STAFF REPORT
(Final Plat)

CASE NUMBER: S/D 95-87 LINDER ADDITION

LOCATION: East of Woodlawn and south of 37th Street North

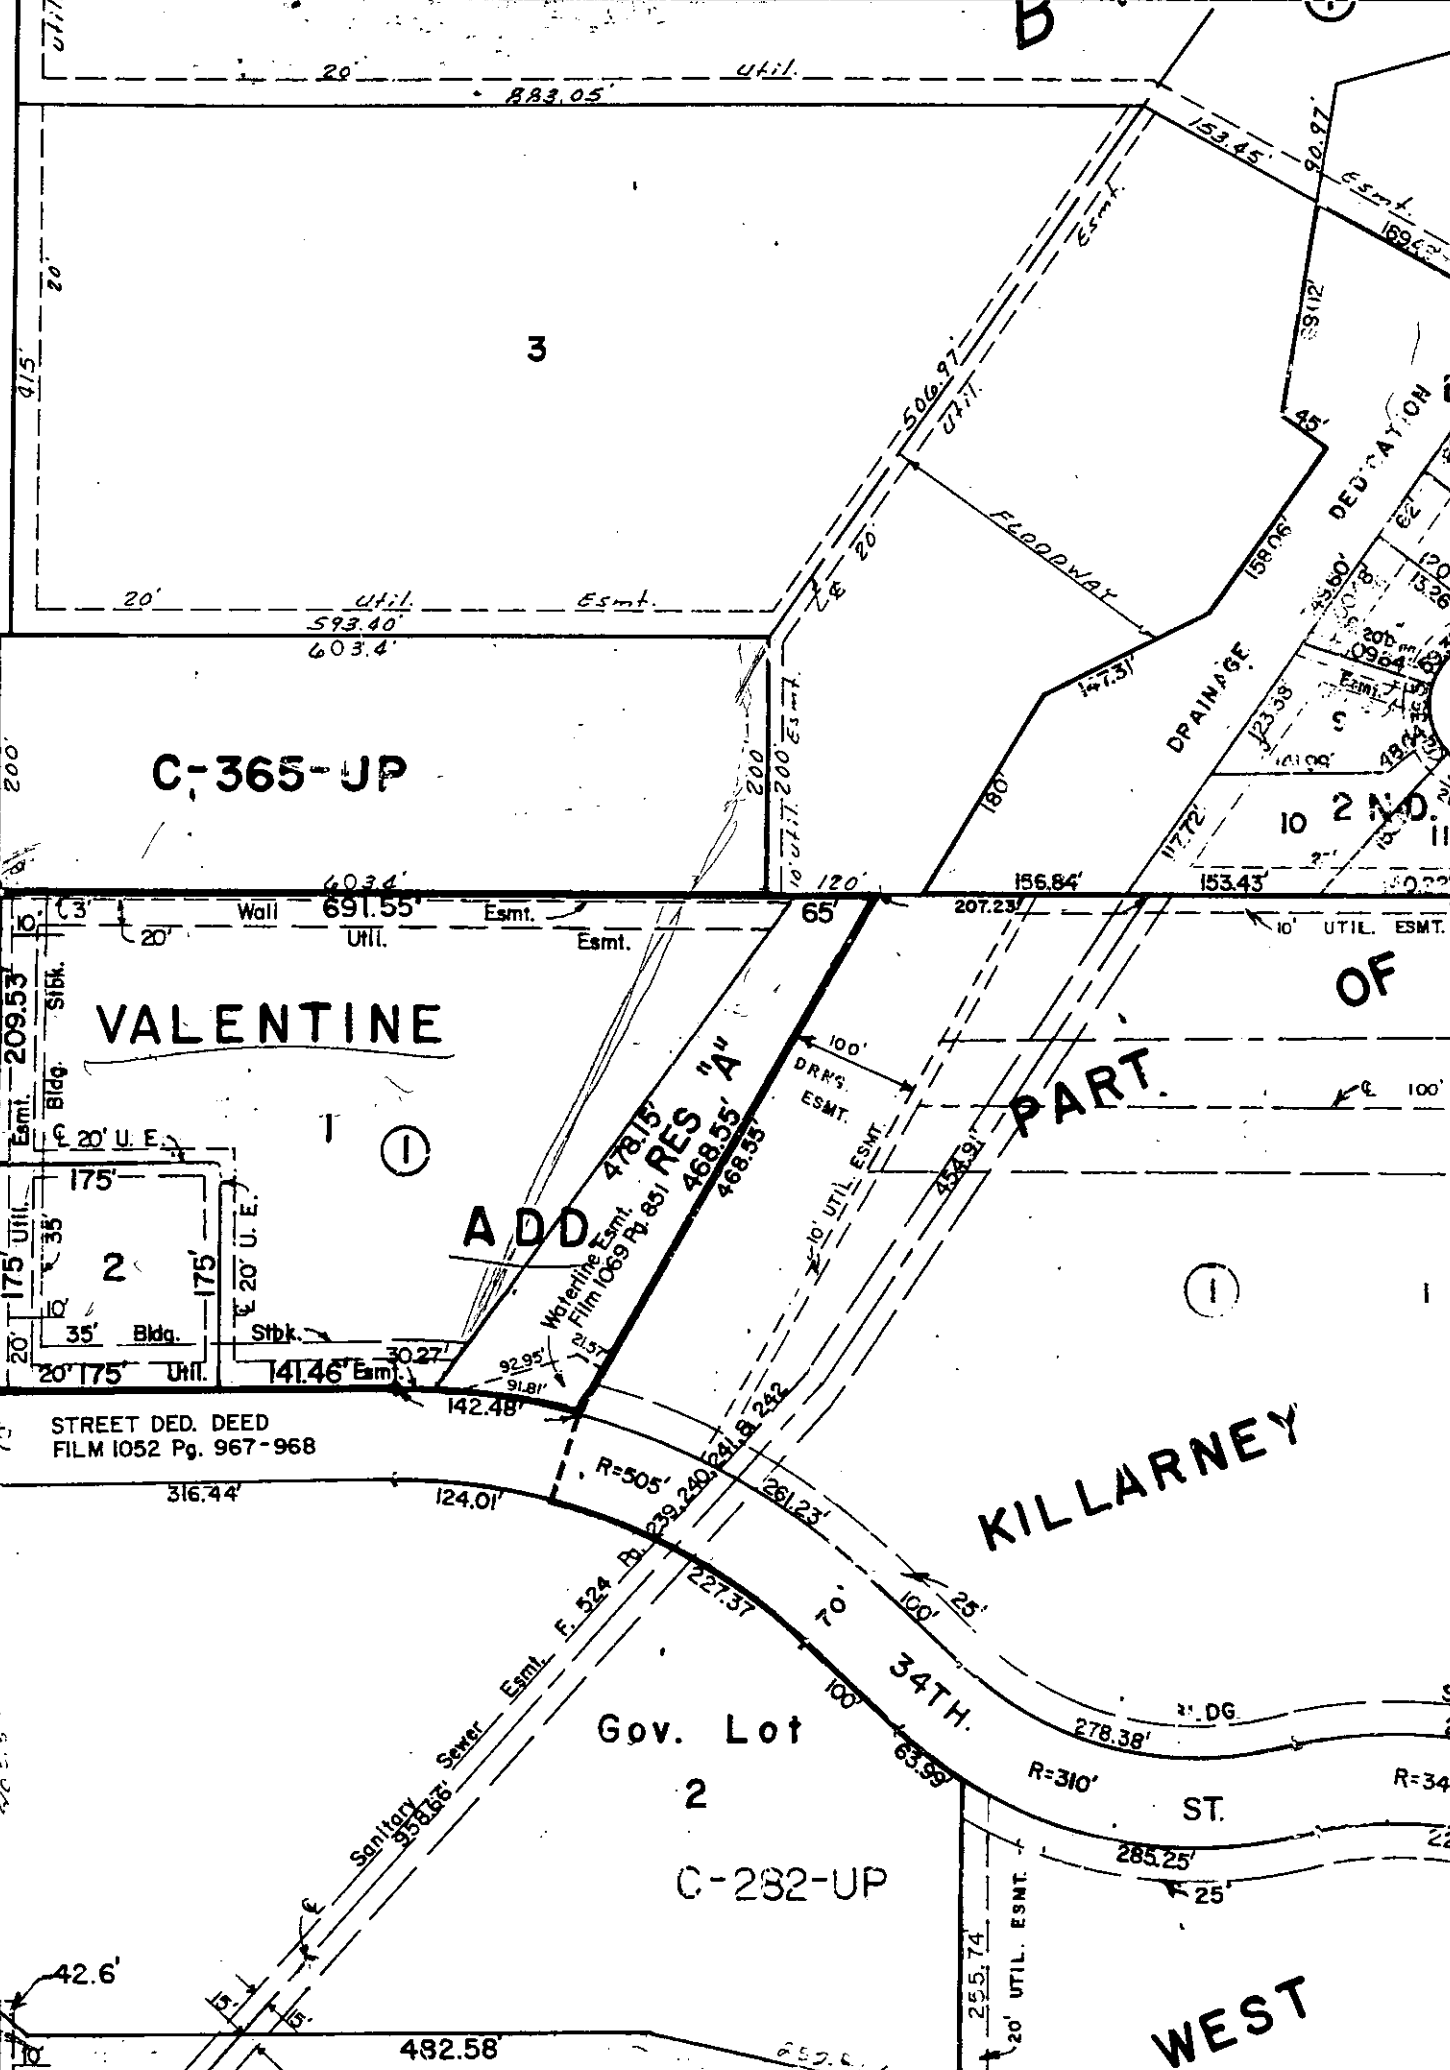
- A. City Engineering and/or the Water Department need to indicate any requirements as to this site's use of municipal sanitary sewer or water facilities. That is, are any guarantees required and/or will this site be required to hook up to any such existing facilities.

- B. The applicant shall guarantee any drainage improvements required by the platting of this property.
- C. If improvements are guaranteed by petition, a notarized certificate listing the petitions shall be submitted to the Planning Department for recording.

- D. Traffic Engineering needs to indicate acceptable access controls for this site. While two openings to Woodlawn presently exist, the "LC" lots to the south, in the Valentine Addition, with similar or even greater frontages, were platted with only one opening per lot. As necessary, the applicant shall guarantee the closure of one drive if only one opening is to be platted and the plat shall be amended accordingly.

- E. In regard to the access control noted in the platting text, the text shall be corrected to note that access control is being dedicated across the lot's "west" line, not the "east" line.

- G. The applicant shall install or guarantee the installation of all utilities and facilities which are applicable and described in Article 8 of the MAPC Subdivision Regulations. (Water service and fire hydrants required by Article 8 for fire protection shall be as per the direction and approval of the Chief of the Fire Department.)

- I. Perimeter closure computations shall be submitted with the final plat tracing. Section 5-101(c).
- J. Recording of the plat within 30 days after approval by the City Council.

- K. The representatives from the utility companies should be prepared to comment on the need for utility easements to be platted on this property.
- L. The representatives from City Engineering should be prepared to comment on the status of the applicant's drainage plan.
